RESPONSE TO COUNCIL INFORMATION REQUEST IN RELATION TO THE REEF MARINA REDEVELOPMENT – COMBINED APPLICATION

The following response is provided to Council's Information Request (IR) issued by correspondence dated 30 November, 2016.

PROJ NO. 160303	DWG NO. DA-2A-102	REVISION: 03
STATUS: DEVELOPMENT APPLICATION

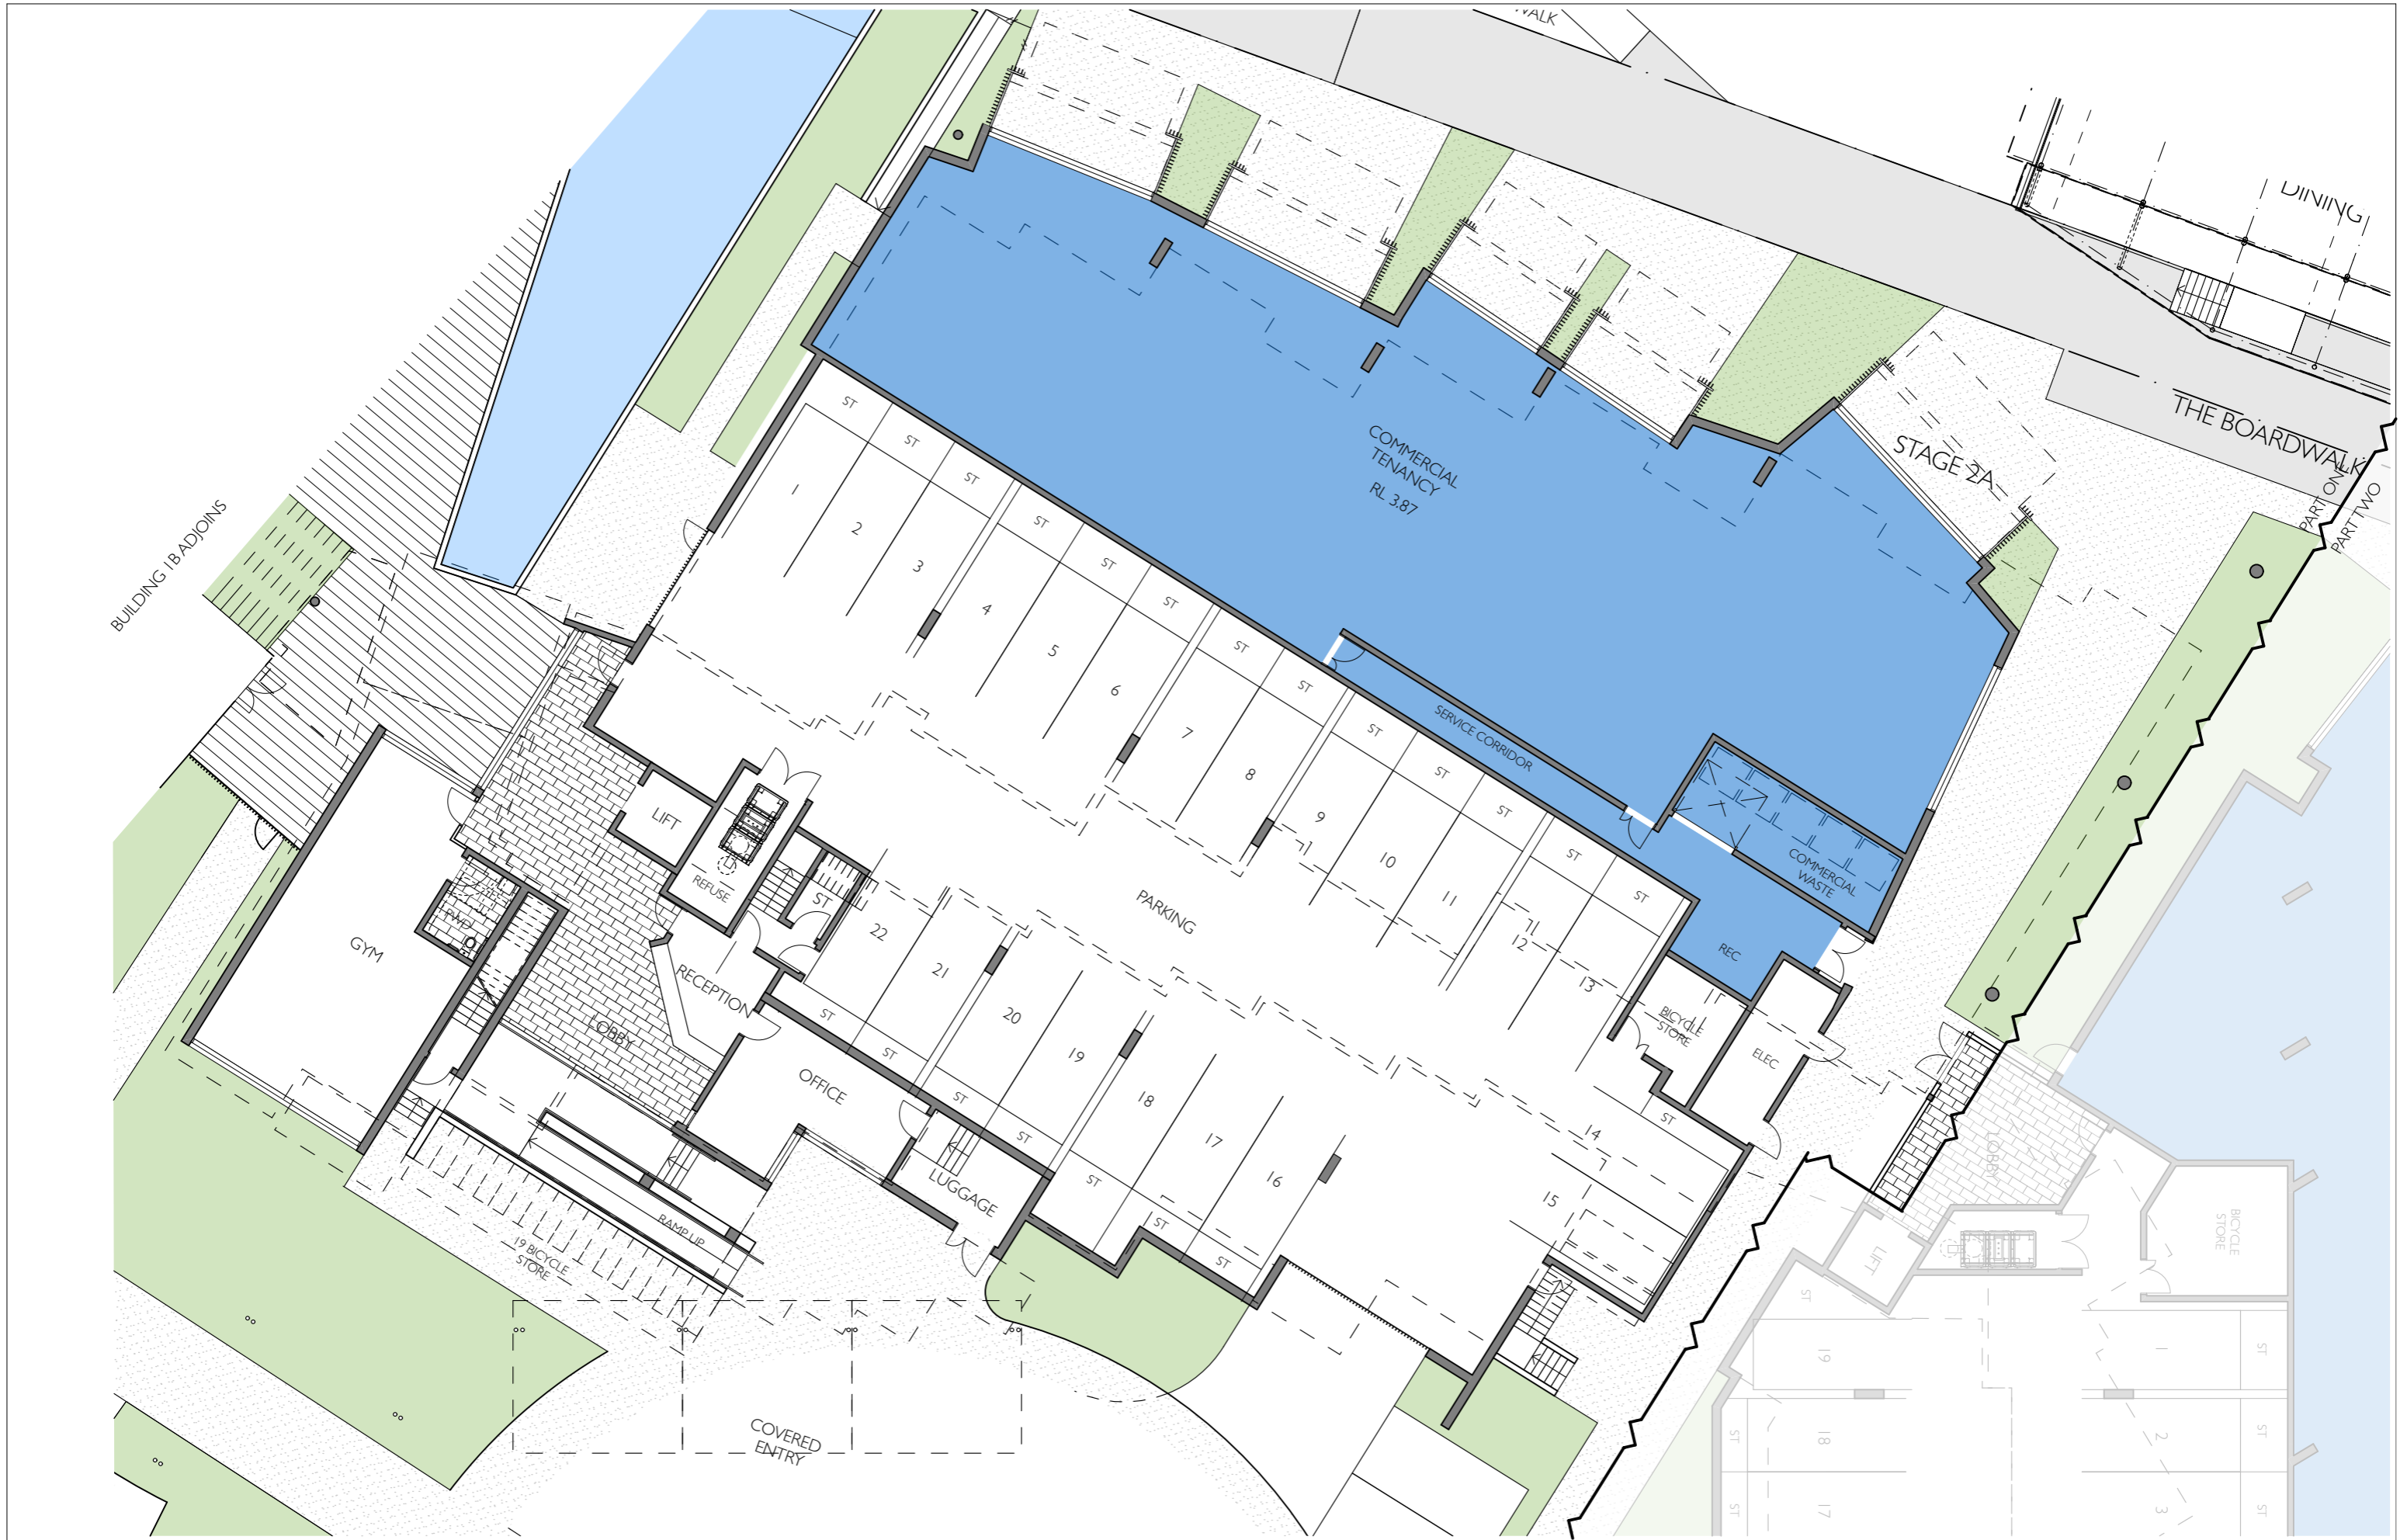
24. Ascending steps appear to commence within car parking space 14 providing access to the internal breeze-way corridor in Level 1. Please amend or clarify this detail.

There are no stairs commencing in the car park – revised drawing DA-2A-102 revision 3, amended to provide clarity, refer Appendix 11.

STAGE 3A SITE PLAN
 1:200

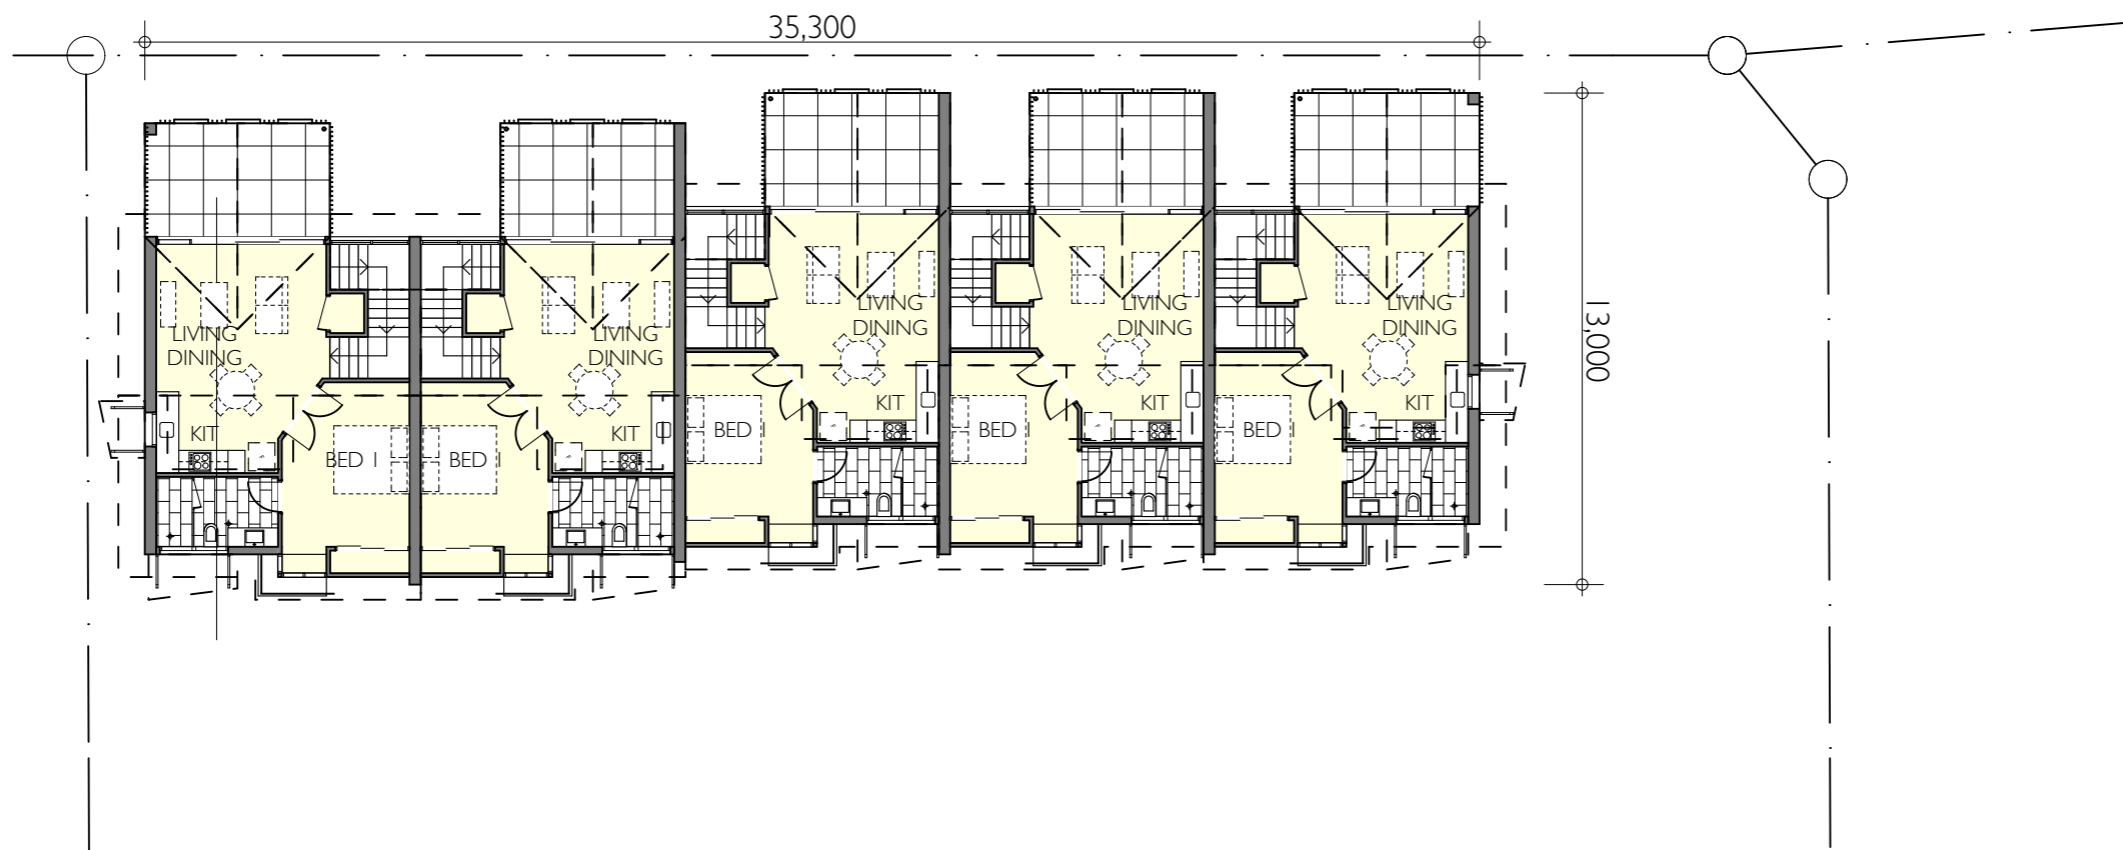
34. Provide details of any fencing (if proposed).

Fencing extent added to DA-3A-101 Revision 03, refer Appendix 12. Fencing will be 1800 high to east powder coated tubular aluminium fencing.

STAGE 3A PLANS

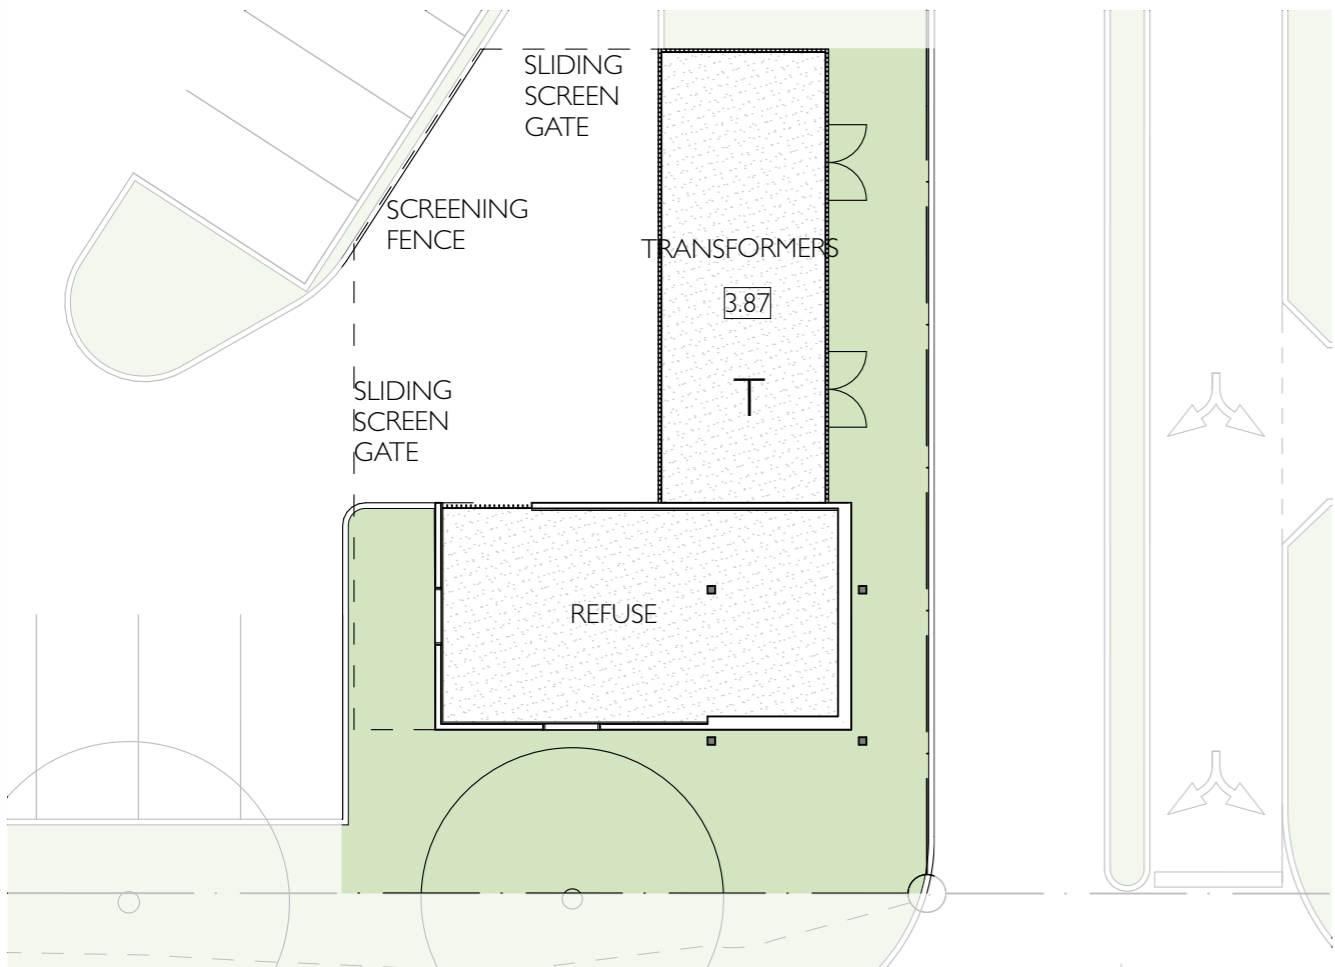
33. Amend the Stage 3A Site Plan and Stage 3 Plans to reflect driveway access to Unit 1's garage.

Drawing DA – 3A – 102 Revision 03 amended and attached at Appendix 12.

APPENDIX: 13

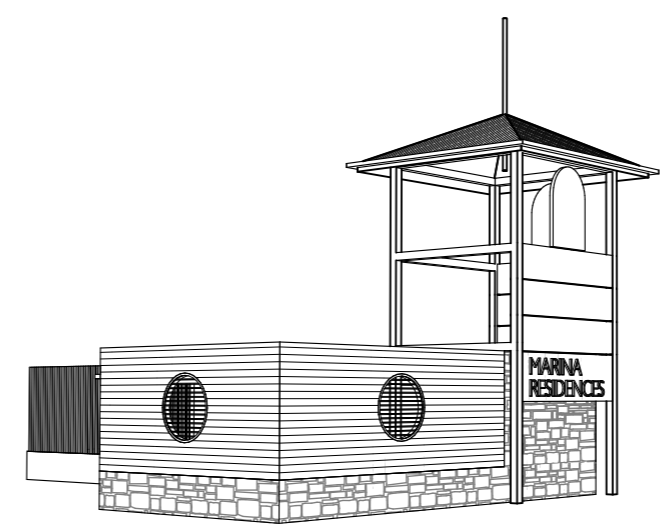
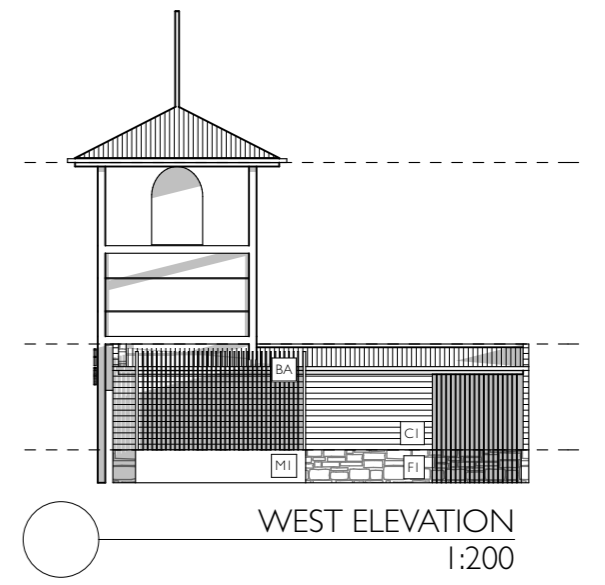
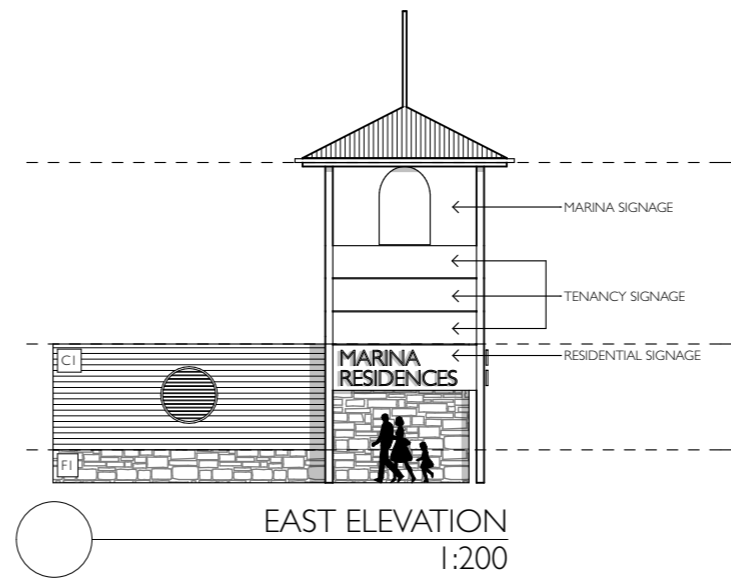
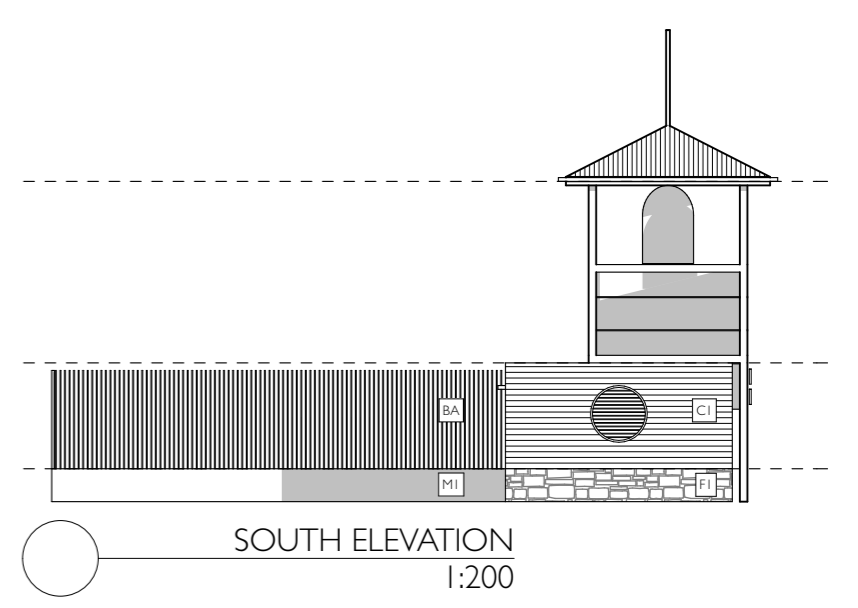
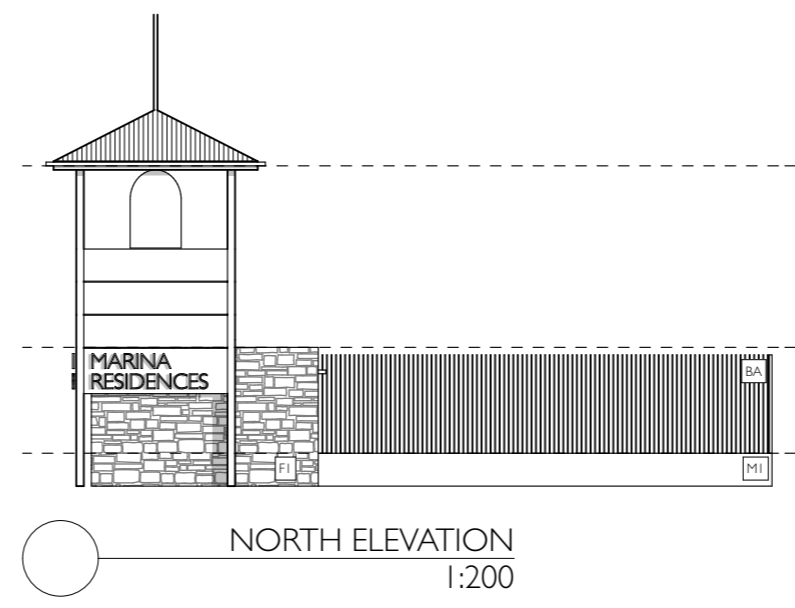
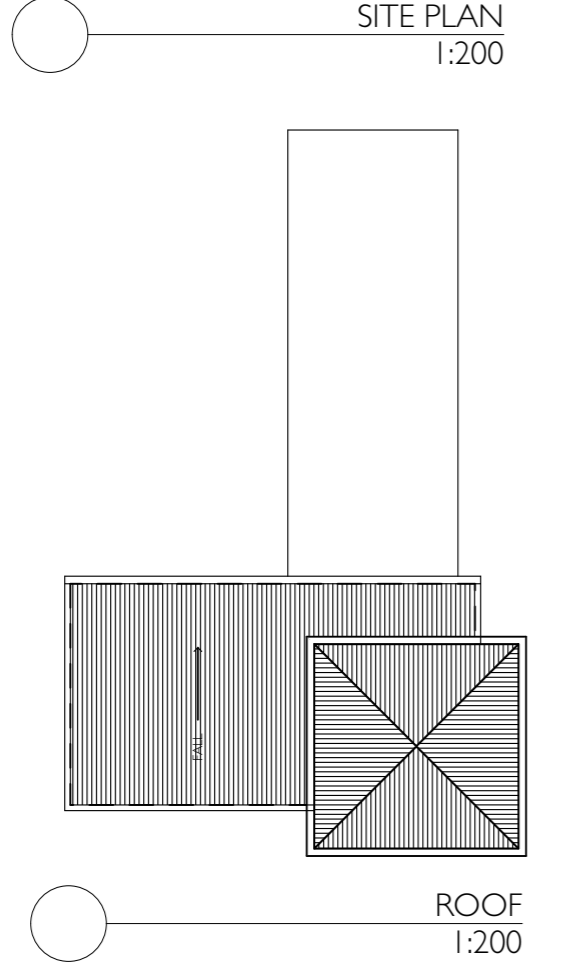
37. The location of the Central Refuse Area and Transformer at the entrance to proposed Coral Close needs review. It is noted that it is shown partially on plans that accompany Stage 2C as part of an entry statement. Either provide more detail on how the Central Refuse Area and Transformer are integrated into the entry statement so as to be unobtrusive or select a more discrete location within the site for these facilities that can be appropriately disguised/hidden from view.

Refer to drawing DA-IR-106 MARINA ENTRY STRUCTURE at **Appendix 13**, for details.

The colour scheme for the entry structure will be:

Roof: Colorbond Surfmist.
Walls: Reef Marina White.
Window/door/Louvers: Duratec Zeus White.
Screen Enclosure: Duratec Eternity Charcoal Pearl or Paint to match.

APPENDIX: 14

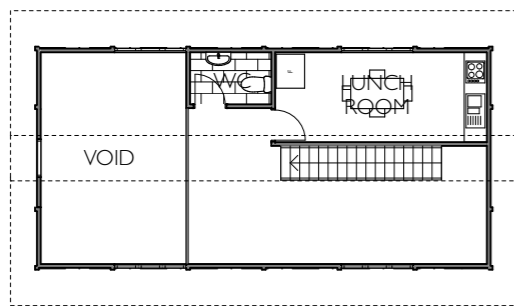
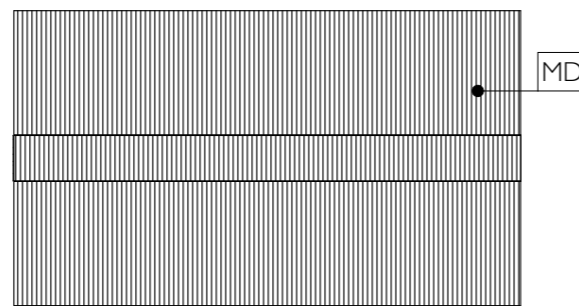
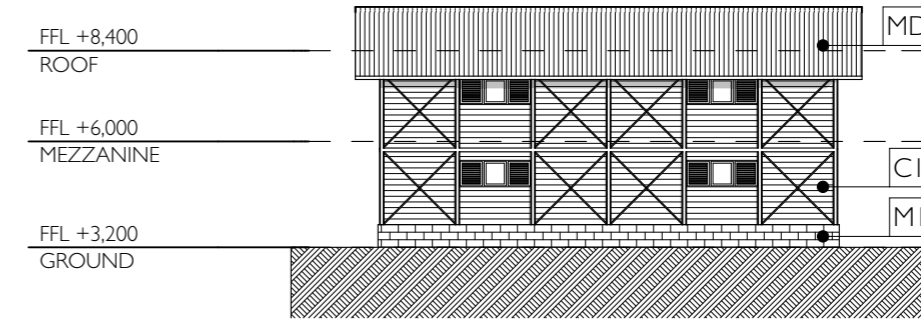
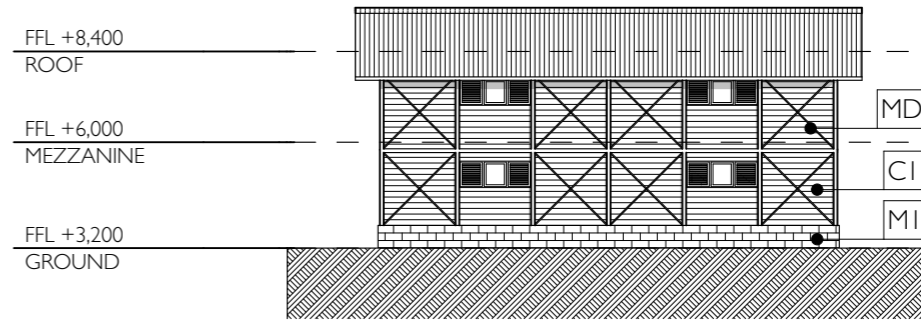
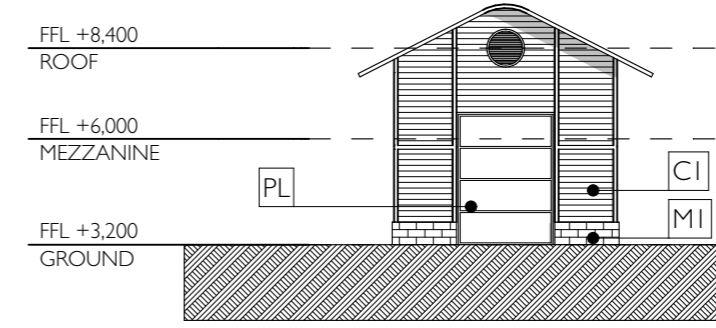
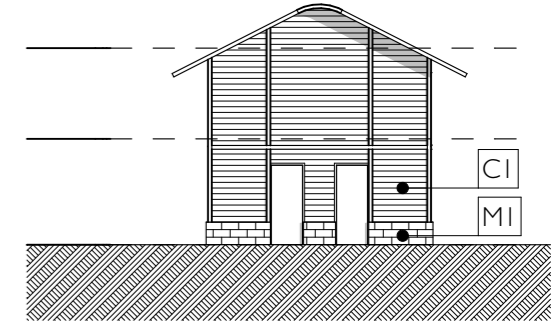
38. Provide details of the maintenance shed close to the units in Stage 3A.

Refer to drawing DA-IR-107 MAINTENANCE SHED at **Appendix 14**, for details.

The colour scheme for the building will be:

Roof: Colorbond Surfmist.
Walls: Reef Marina White.
Window/door/Louvers: Duratec Zeus White.
